HATCHER-SAYRE, INC.

December 16, 1988

Re: Freeman Chemical Corporation
Corrective Action Order
Task 3, Project Plans
Job No. 0001-003

JOB #: 0001-003	SCALE: 1":100'	SOIL SAMPLING LOCATION MAP
DATE: July 1, 1988	DRAWN BY: Eva	 HATCHER INCORPORATED

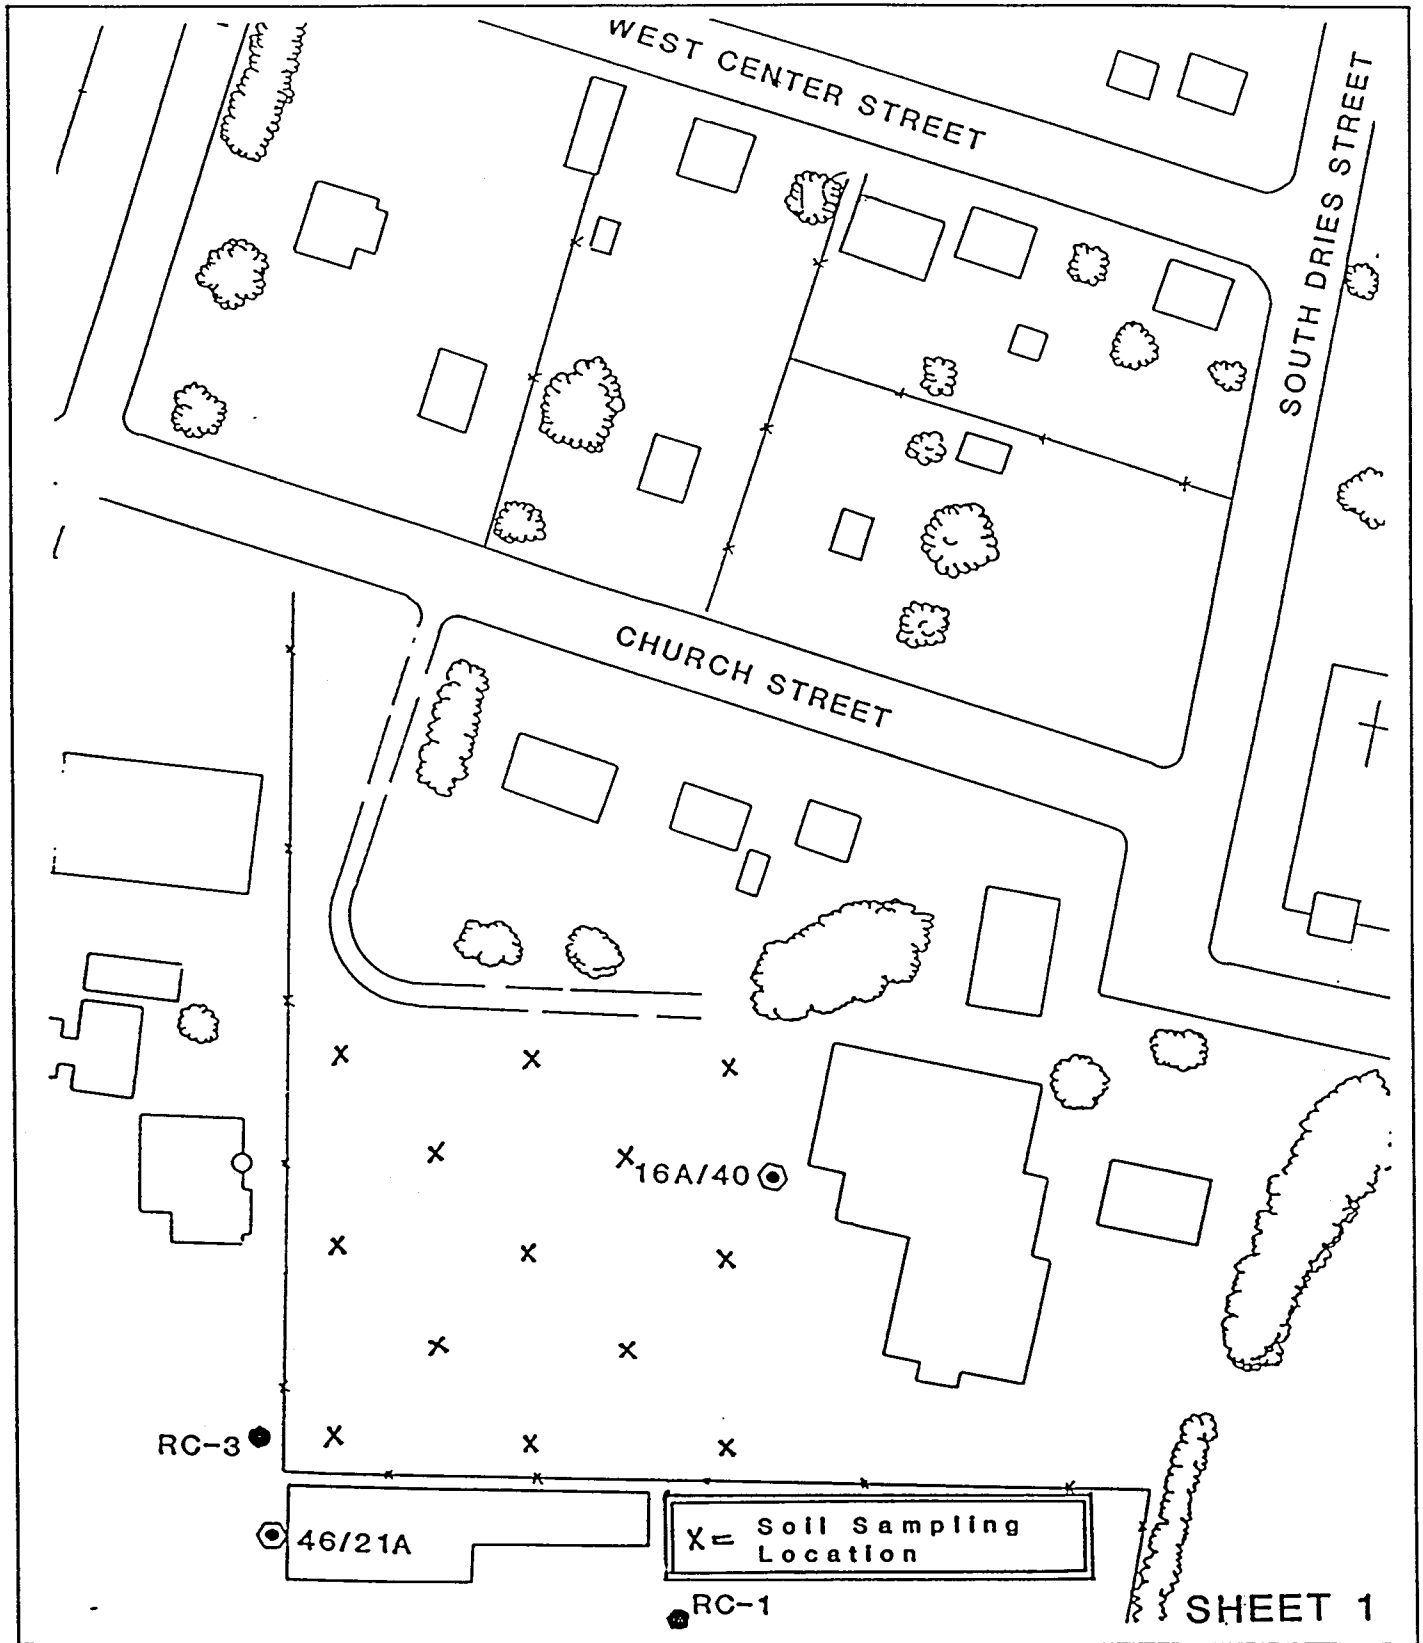
1. CHURCH YARD SAMPLING/TESTING PROGRAM

The USEPA and WDNR have expressed concern about the presence of volatile organic compounds at shallow depths directly beneath the church property. In order to address this concern, we propose to drill 13 hand auger borings to depths of 3 feet at the locations shown in Sheet 1. Each location will be sampled at 12" - 14" and 36" - 38" depths unless we meet auger refusal at a lesser depth. If we are unable to hand auger to 36", we will move the sampling location. If this is unsuccessful, we will sample from the depth closest to 36". The sampling will be accomplished by first drilling with a hand auger to the specific sampling depth. Then, a hand driven soil core sampler will be used to obtain a 2" long and 1.9" O.D. soil sample. A description of the sampling equipment is included as Sheet 2. The sample will be contained in a 2" long, thin wall aluminum retaining cylinder. Upon completion of the sampling, the cylinder will be removed from the sampler, immediately covered on both ends with teflon tape and capped with plastic cover, then placed in an ice chest. The hole will then be extended to the next sampling depth, and sampling performed at the next interval. Hand auger cuttings will be taken 3" above and below each soil core sample interval and placed in a clean glass jar for field head space analysis with an HNU PID. The head space analysis will not be performed on the individual soil core samples in order to minimize the escape of the VOC's. A total of 26 samples will be taken and sent to ERCO in Cambridge, Massachusetts for HSL 624 volatile organic compound analysis.

SEISMIC REFRACTION
LOCATION MAP

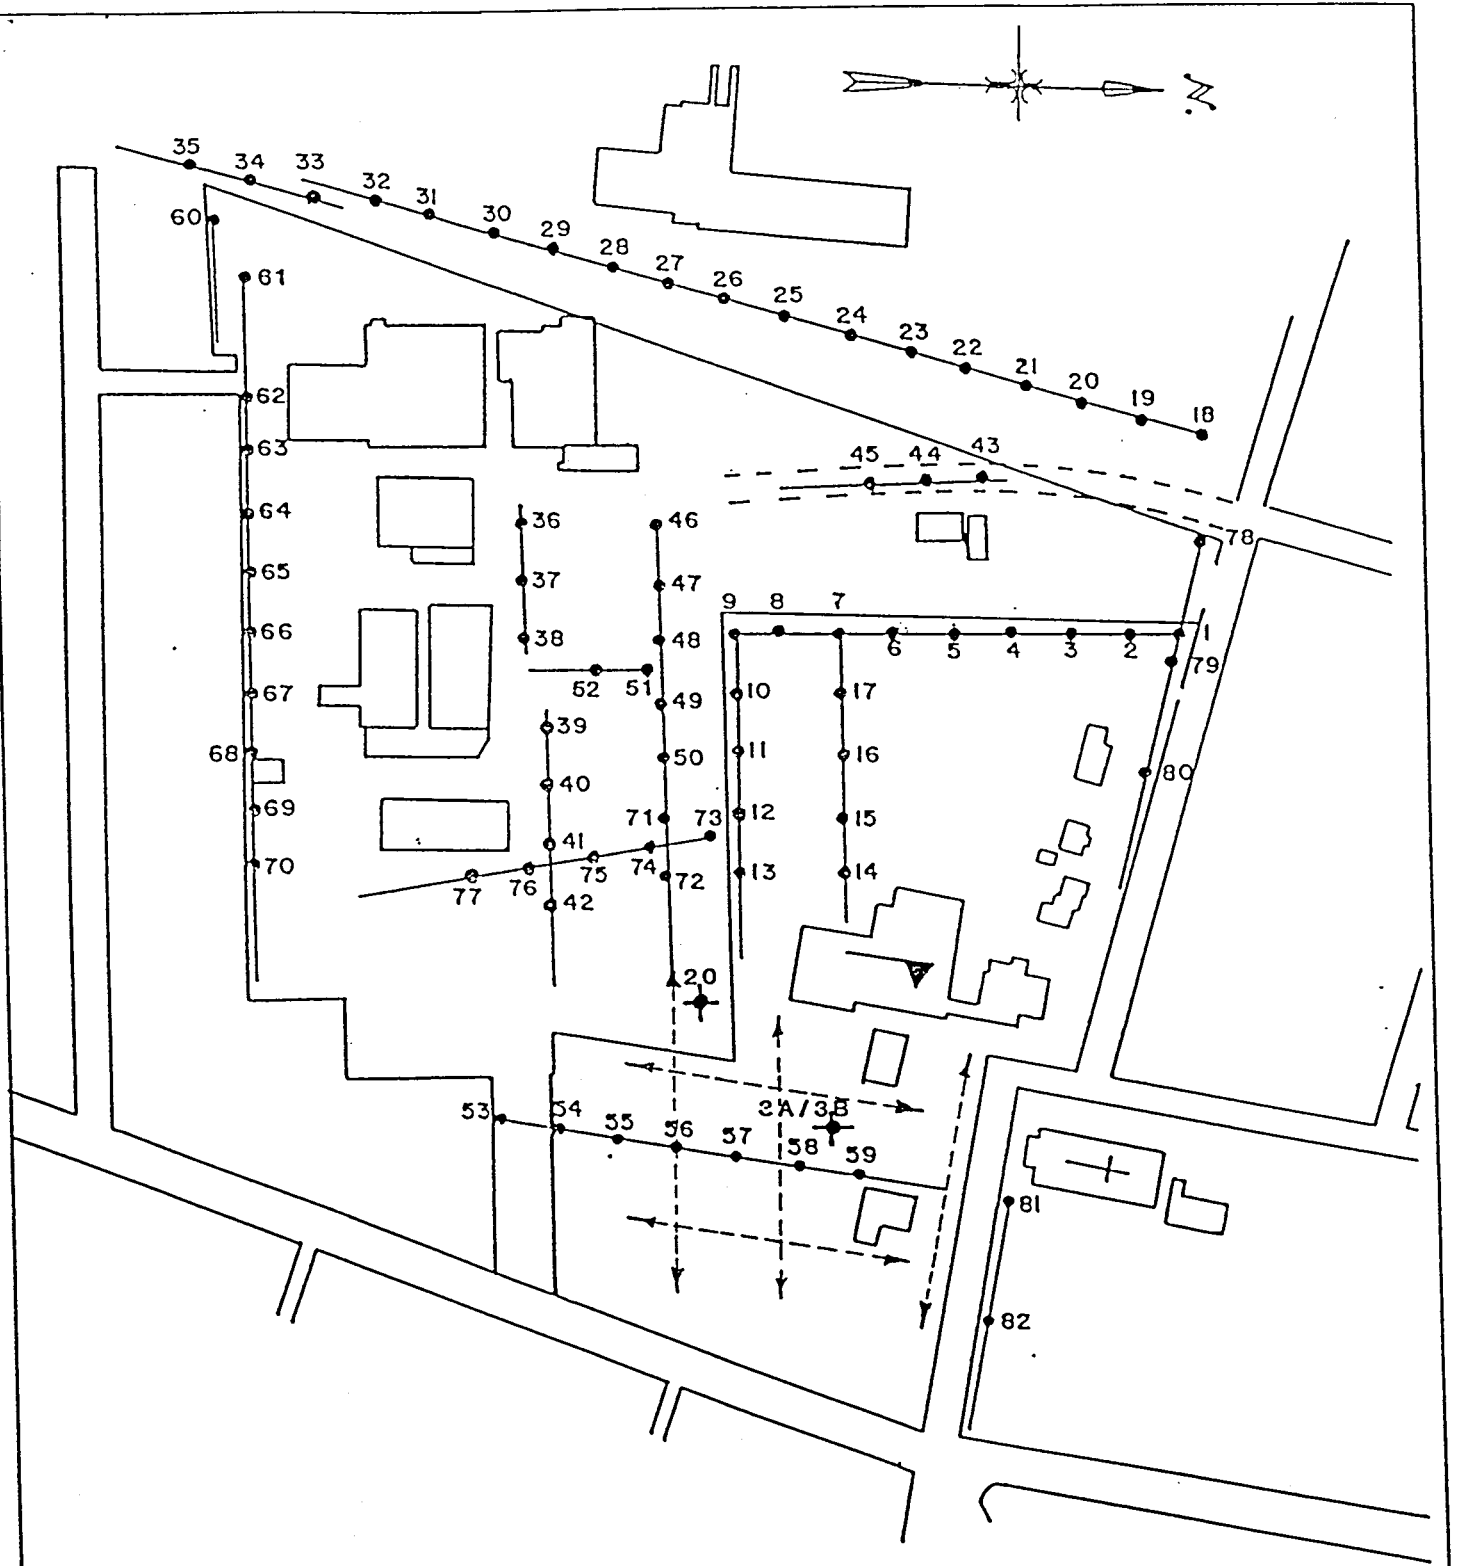
2a. HYDRAULIC RELATIONSHIP BETWEEN THE
SINKHOLE/RIVER CHANNEL AND THE DOLOMITE AQUIFER

Subsurface data developed from the many soil borings and monitoring wells installed on-site indicate that glacial-fluvial sediments of variable thickness overlie a highly irregular dolomite rock surface. This irregularity is the result of karstification. Two wells drilled previously near the northeast corner of the Freeman property (one on-site and one off-site) encountered either an ancient river channel or a sediment filled sinkhole. Approximately 205' of alluvial sands and clayey silts were penetrated in Well 3A. In Well 20, just to the west of Well 3A, 170' of overburden was penetrated without encountering bedrock. Based on this data, it is estimated the base of this ancient channel or sinkhole is about 175' below the present Milwaukee River channel. Since ancient stream channels and sinkholes have a direct hydraulic influence on recharge to the Dolomite Aquifer, it is important that the physical configuration, areal extent and general hydrologic properties of this feature be determined.

We propose to investigate this area by performing a geophysical survey consisting of a series of seismic refraction survey lines. This program will be supplemented with previous seismic refraction data developed in this general area in 1985. We believe this approach will provide the necessary subsurface data, without drilling numerous borings, to determine the physical character of the feature. A minimum of five 200 to 300 ft. long traverse lines are planned. Proposed locations as well as previous traverse locations are presented on Sheet 3. The actual location of the lines will be controlled in part by physical features such as buildings and fences. Much of the area of interest is off-site, and it will be necessary to obtain permission to work in these areas. Upon completion of the geophysical survey and reduction of the data, at least one well will be drilled to verify the data. The well will be drilled and constructed so that hydrogeologic data can be obtained from this area during performance of the Dolomite Aquifer pumping test, which is described later in this submittal. Data developed during the test from this well will be used in determining the hydraulic relationship between this feature and the Dolomite Aquifer.
